SERVICE BULLETIN 95

SUBJECT: GLASAIR III LANDING GEAR OLEO STRUT WELDED JOINTS

APPLICATION: All Glasair III landing gear oleo struts
(Serial numbers 051 to 101 in particular)

FIGURE (1)

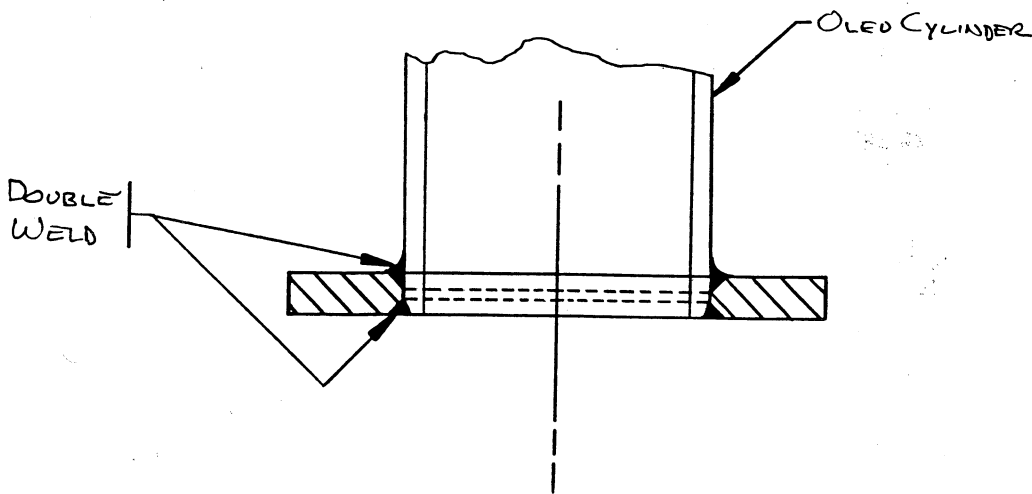
DESCRIPTION: We recently received notification of a failure of the weld at the junction between the chrome oleo cylinder and the fork mounting flange (see illustration). The failure, which occurred on a customer's Glasair III nose gear, resulted in damage to the propeller and required an engine tear-down.

On this initial run of landing gear, the weld that joins the fork attach flange to the oleo cylinder interferes with the fork mounting hardware. A bevelled washer was manufactured and installed to remedy this problem. The desire to eliminate weld interference with the fork attachment bolts led us to seek an alternative manufacturing method. Thus, we decided to post-machine the welds on the second production run gear struts in a manner similar to the Glasair I gear, which had been in service for years.

The cylinder that failed came from the second production run of Glasair III landing gear. In this lot, the weld was post-machined to provide clearance for the fork attachment bolts. Possible causes of this failure could be uneven weld penetration compounded by post machining, weld cavities, etc. or an extra hard landing. A hard landing may cause a break or a crack in a weak weld. Subsequent takeoffs and landings could then cause the crack to propagate.

These third production run cylinders have the smaller radius welds to eliminate interference with assembly bolts, but use a different mounting flange design than the first and second production runs. Redesign of the mounting flange allowed a secondary weld to the cylinder on the lower side of the flange and eliminated the deep countersink that invited uneven weld penetration and weld cavities. (Refer to FIGURE [1].)

It is difficult to predict the extent of the problem or the potential for failure for second production run landing gear. Therefore, we will advise but not require replacement of the chrome oleo cylinders for gear struts with serial numbers 51 to 101. The replacement cost of these components can be considered inexpensive insurance compared to the replacement cost of a propeller, an engine tear-down, or the cost of other components that could be damaged as a result of a gear strut failure.

Since we stock only a few replacement cylinders, we will initiate a special production run of these parts for Glasair III builders who wish to upgrade their oleo struts to the most recent design.
